Corn Hill Landing Public Art Competition UPDATES

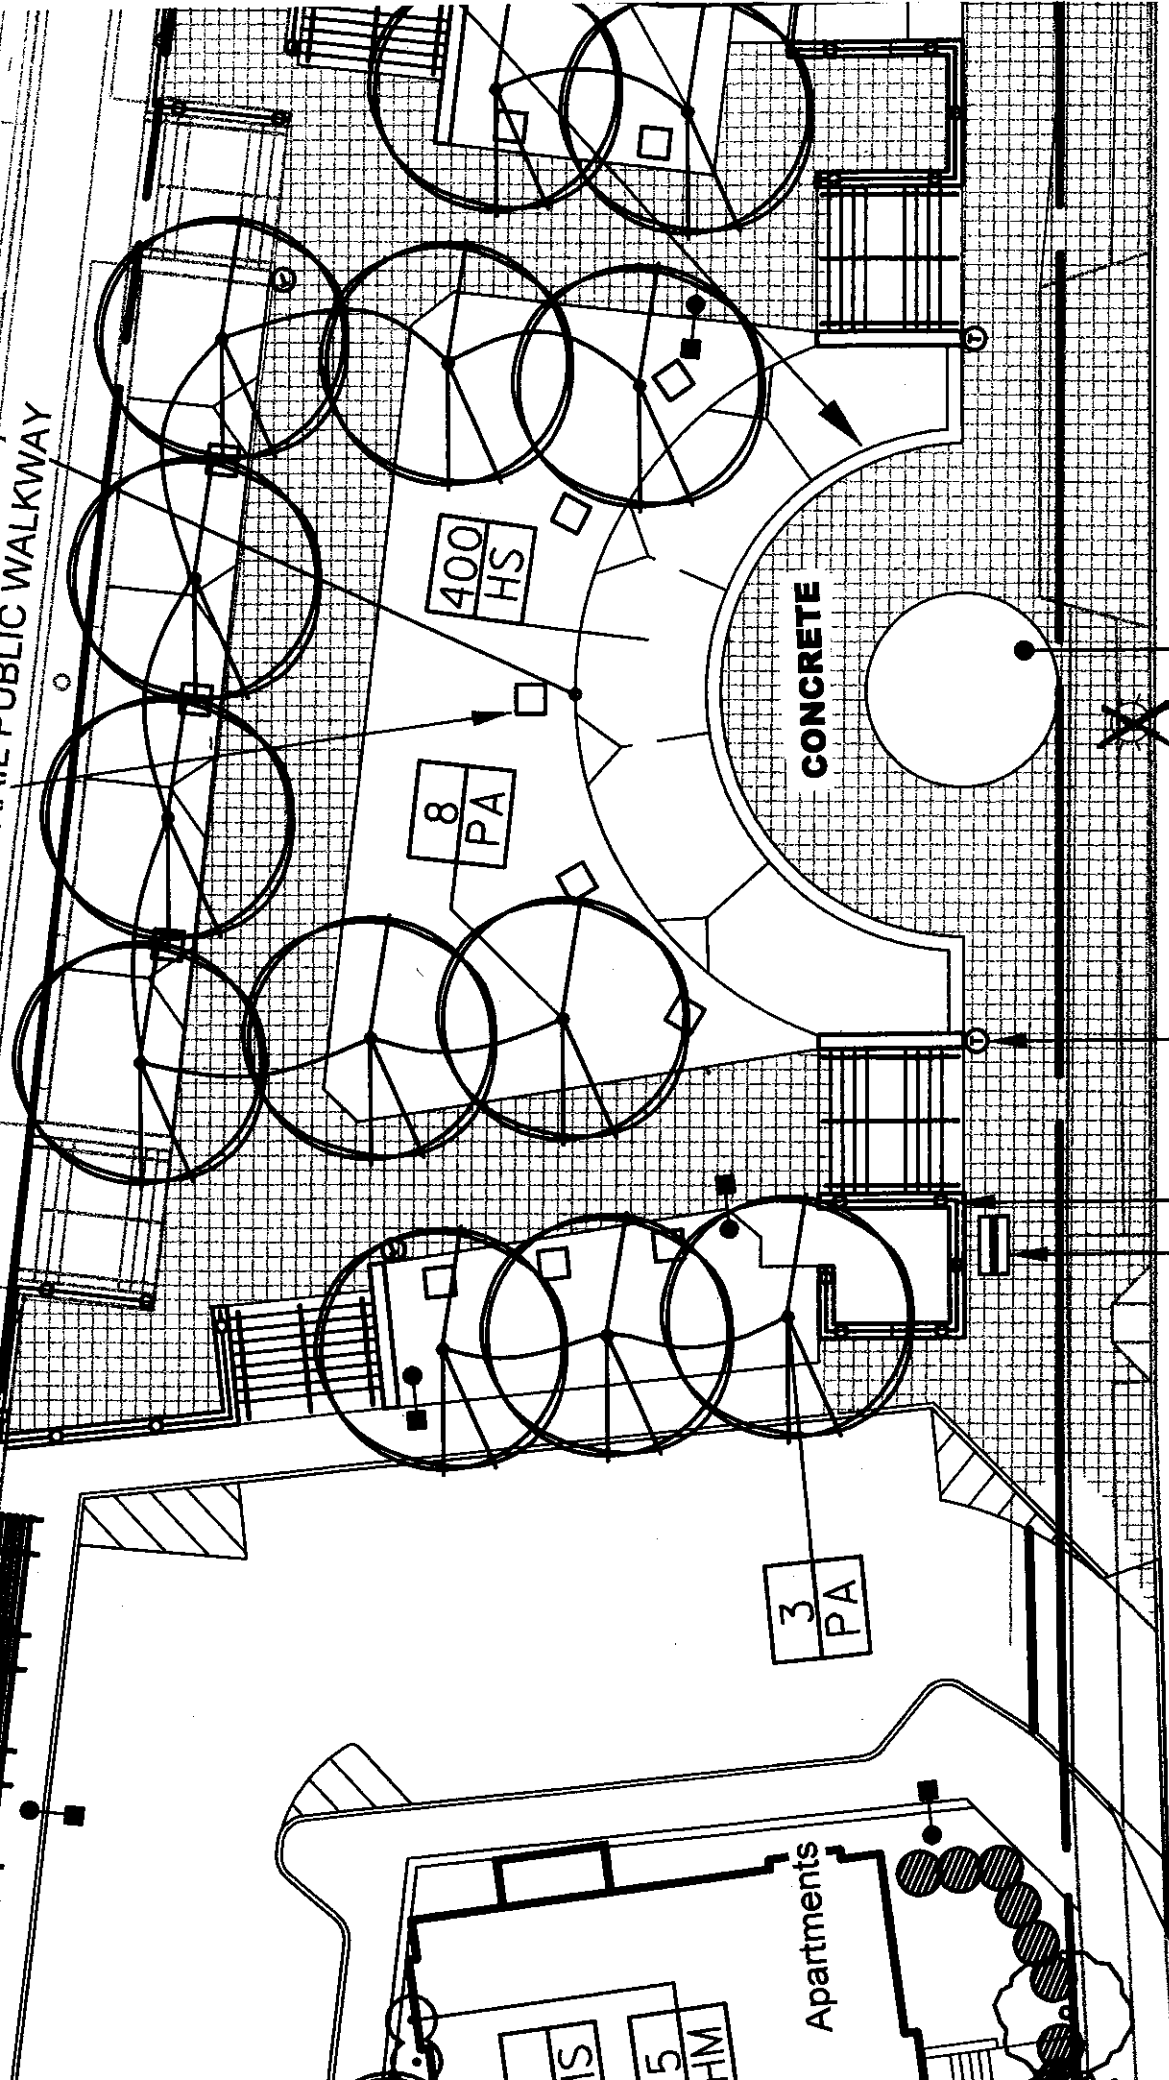
3. CORRECTION: The circular pavement area surrounding the location for the public art will be paved with concrete prior to the public art installation. Therefore, the artwork proposal should either avoid specialized treatment for this pavement area or include the costs associated with replacing the concrete with such specialized treatment. See following page.

optional: flower bed and sculpture base within this area.

CLARIFICATION: ALL AREAS SHOWN CROSSHATCHED SHALL BE
PLAIN CONCRETE SIDEWALK. May 23, 2006
